**CITY OF KELOWNA
MEMORANDUM**

APPLICATION NO. DP06-0087 **APPLICANT:** Richard Beavington
DVP06-0081

PURPOSE: TO OBTAIN A DEVELOPMENT PERMIT TO ALLOW FOR THE
RELOCATION OF A SECOND DWELLING UNIT ON THE SUBJECT
PROPERTY.

TO OBTAIN A DEVELOPMENT VARIANCE PERMIT IN ORDER TO
VARY THE REQUIRED LOT WIDTH FOR THE RM1 - FOURPLEX
HOUSING ZONE FROM 20 M REQUIRED TO 18 M PROPOSED.

Barber House Elevations

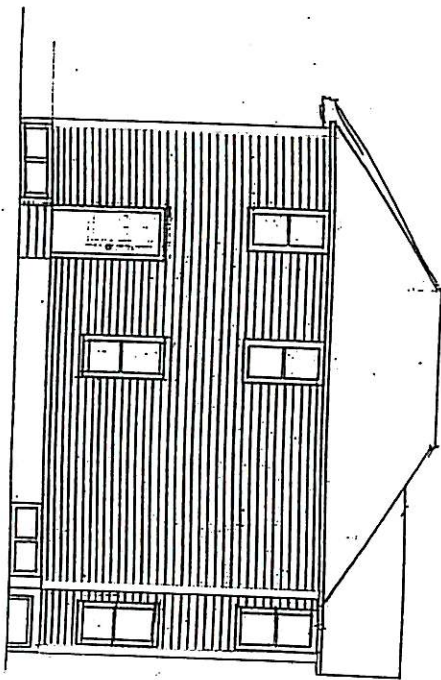
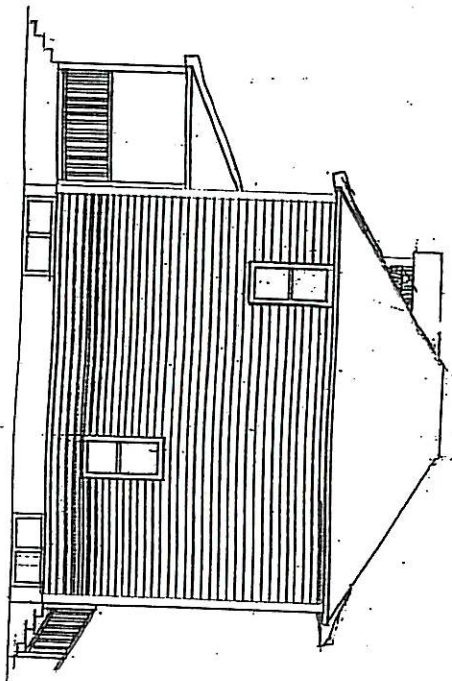
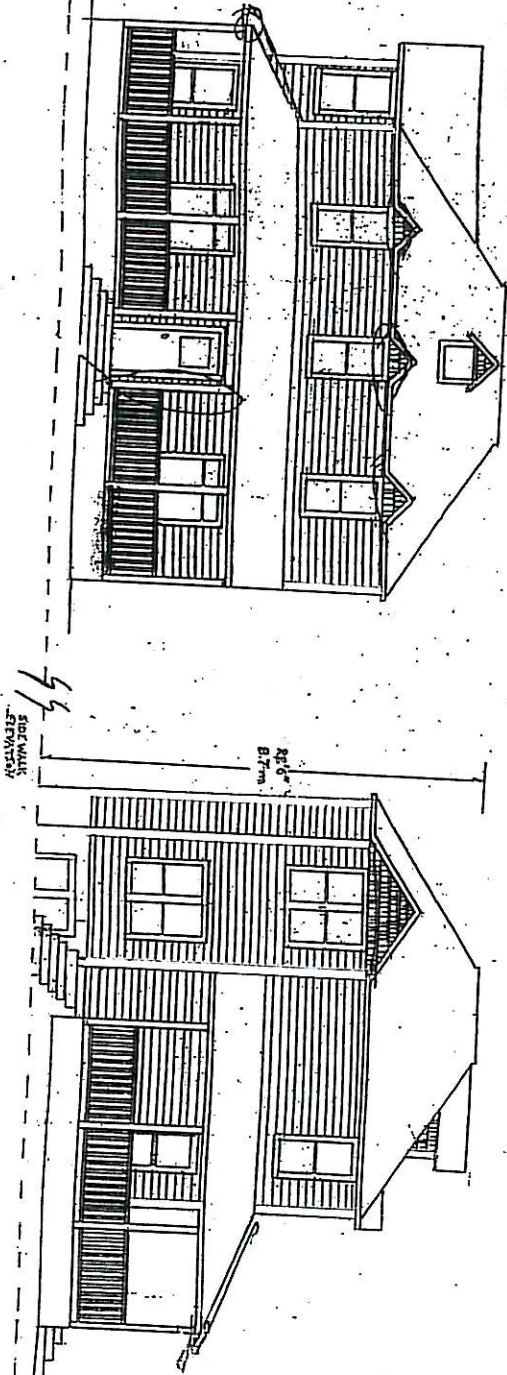
- corner detail needs to be added, once the stucco siding is removed (Staff has added this detail to the drawings);
- eaves could be extended further; also ensure that if soffit needs replacing that it is done in wood, not vinyl;
- gable detail using cedar shakes, or convincing, durable substitute (e.g. Hardi-plank) is good;

- ensure supporting columns on veranda properly proportioned (i.e. appear a bit thin on drawings)

LANDSCAPE WITH REVISED PARKING

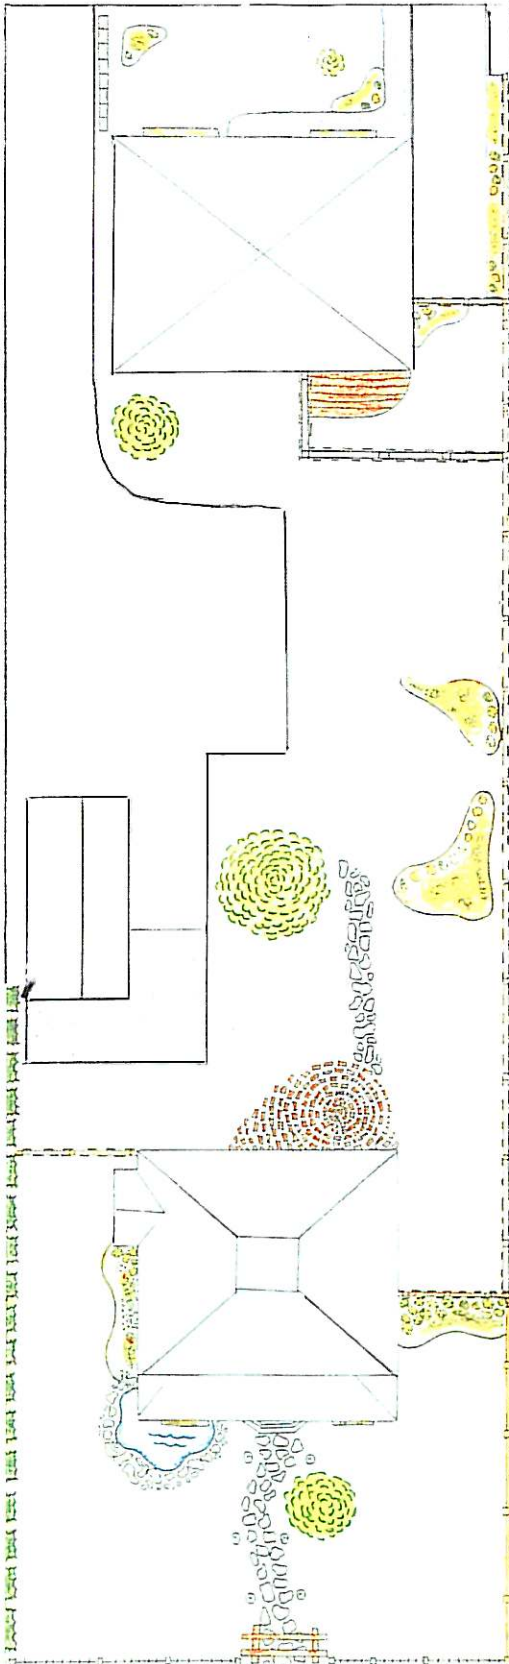
- reduce parking and driveway area to a minimum; ensure durable dust free surface, and preferably something that provides texture and a residential character (e.g. concrete pavers, as opposed to asphalt);
- ensure privacy fencing and/or vegetative screening on both the north and south property lines;

NOTE: The Applicant has revised the site plan to show an improved parking layout, which complies with the requirement of the Zoning Bylaw.
